Interactive comment on “Technical note: using Distributed Temperature Sensing for Bowen ratio evaporation measurements” by Bart Schilperoort et al.

Received and published: 27 September 2017

Fig. 1. Schematic drawing of one section of screen

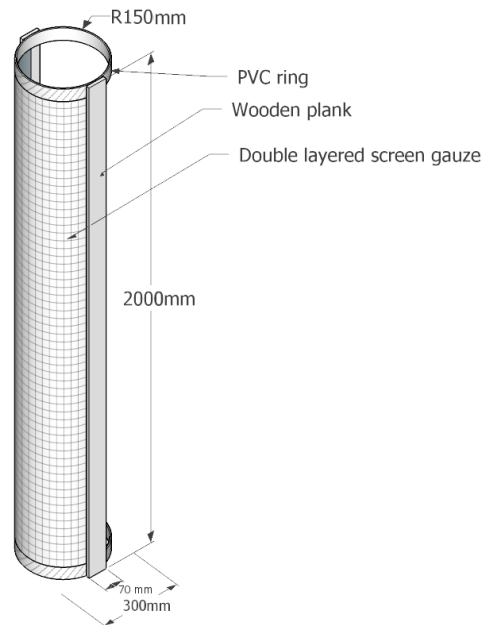
Page 7 Line 5, “The cables were shielded from direct solar radiation using screen gauze secured onto PVC rings”, please describe more about screens, e.g. materials, size and manufacturers. These are quite important as different screen gauzes may lead to different shielding effects.

We should indeed have included more information about the screens, and will do so

in the revised manuscript. The attached Fig. 1 shows a schematic drawing of one section of screen. The screen gauze we used has coated fibreglass as material, with square holes with a width of 1.5 mm and a gauze material width of 0.3 mm. We used two layers on top of each other to achieve a higher reduction in solar radiation.
